## FINDING OF NO SIGNIFICANT IMPACT

### **Preserve Historic Peirce Mill Rock Creek Park**

**PRESERVE HISTORIC PEIRCE MILL**  
**ROCK CREEK PARK**  
**ENVIRONMENTAL ASSESSMENT/ASSESSMENT OF EFFECT**  
**ERRATA**

**Rock Creek Park  
Preserve Historic Peirce Mill EA/AoE  
NPS Response To Comments**

Photograph 2. Front (western side) of Peirce Mill. (Source: Quinn Evans Architects).

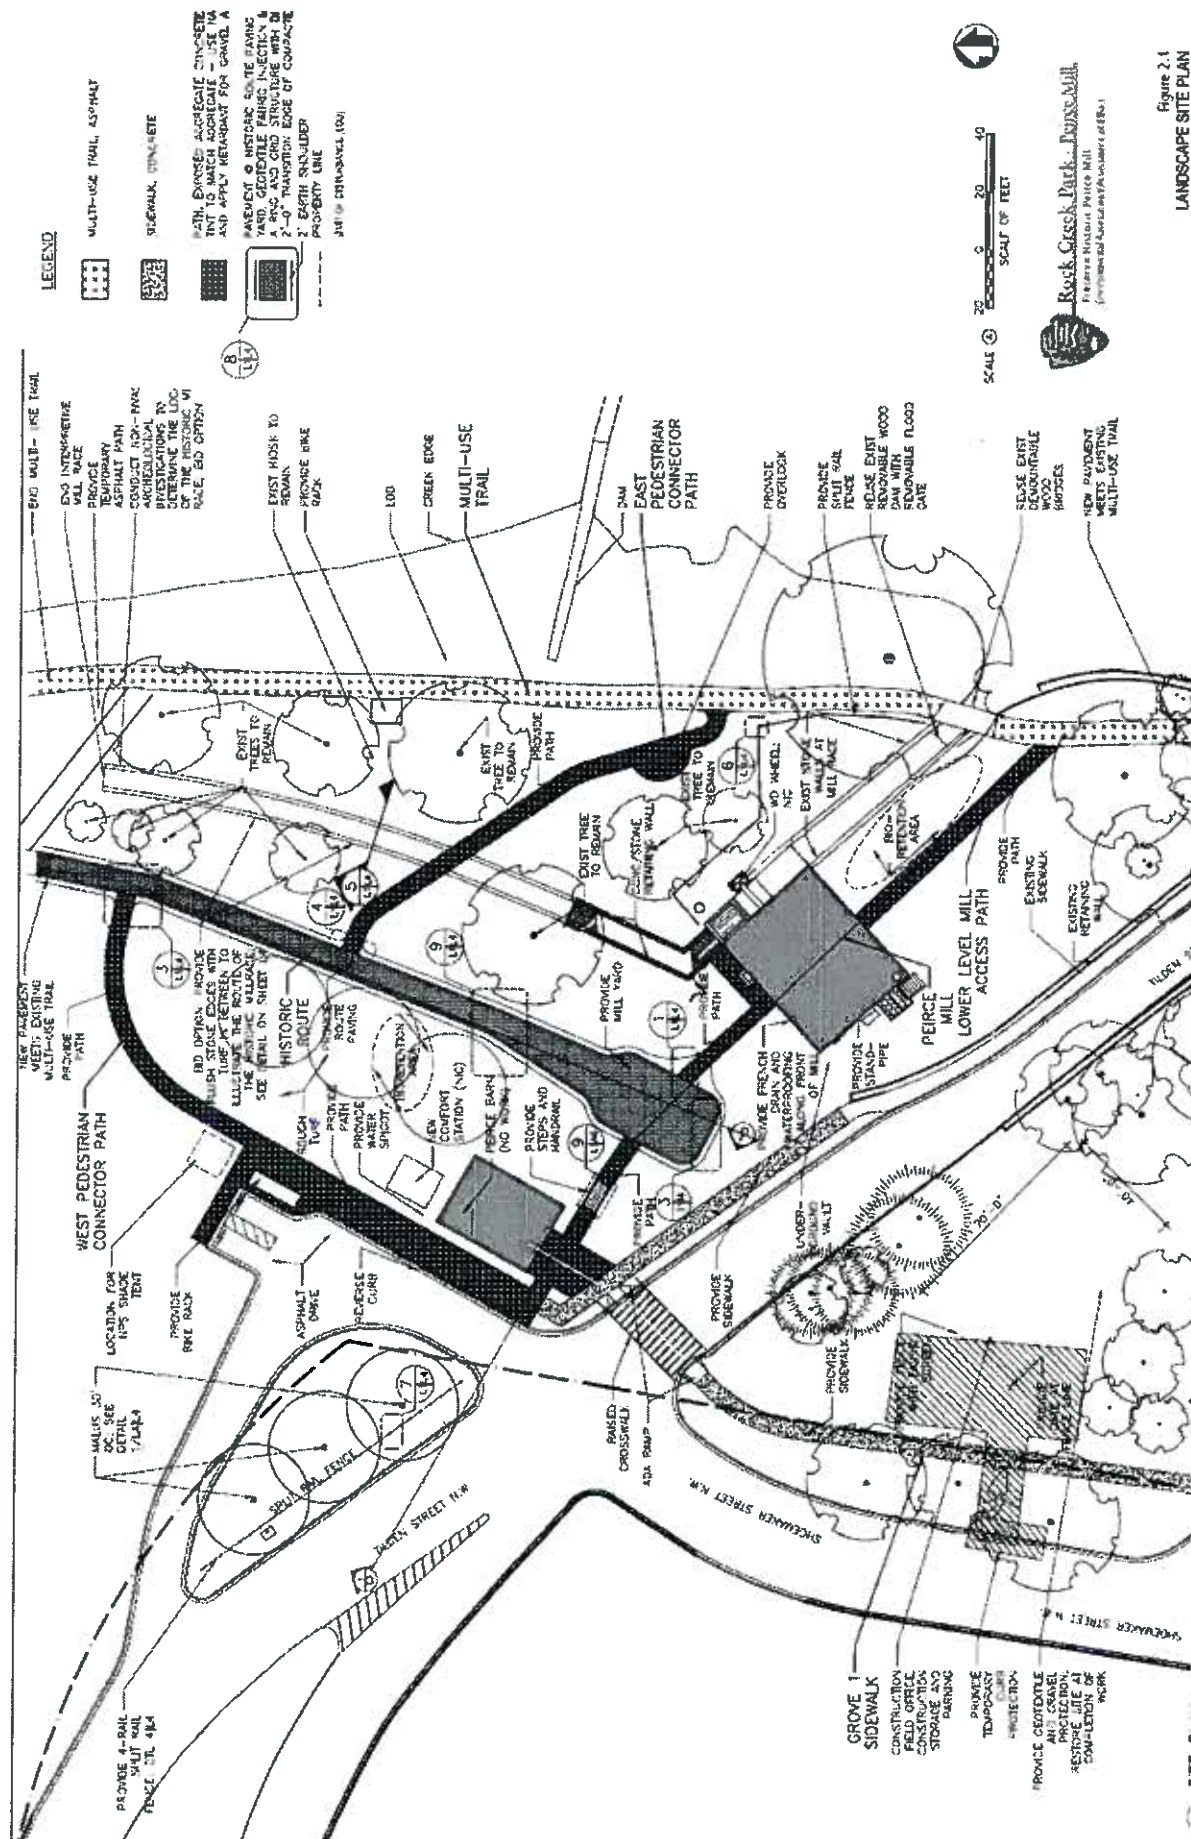
25	Richard D. Abbott – President/Friends of Peirce Mill	02/12/2010	Note that the pictures on page 49 refer to the west and east sides of the mill, which is the way we have always referred to it. To further confuse things, the second picture labeled as the back or eastern side is actually another photo of the west front.	Photograph 2 caption revised as follows: Photograph 2. Front (western side) of Peirce Mill. (Source: Quinn Evans Architects). Please refer to the Errata.
26	Richard D. Abbott – President/Friends of Peirce Mill	02/12/2010	Page 20, 3 <sup>rd</sup> para: It's not clear to us how the headrace length of 65 feet was measured. According to the B/B drawing A1, the headrace actually extends about 40 feet from the point of the turn, measured on the west side.	Text revised as follows: "The new headrace would extend up to approximately 65 feet following the course of the 1930s era millrace to a depth of 6 feet." Please refer to the Errata.

### **8. PHOTOGRAPH 2 [PAGE 49, CAPTION]**
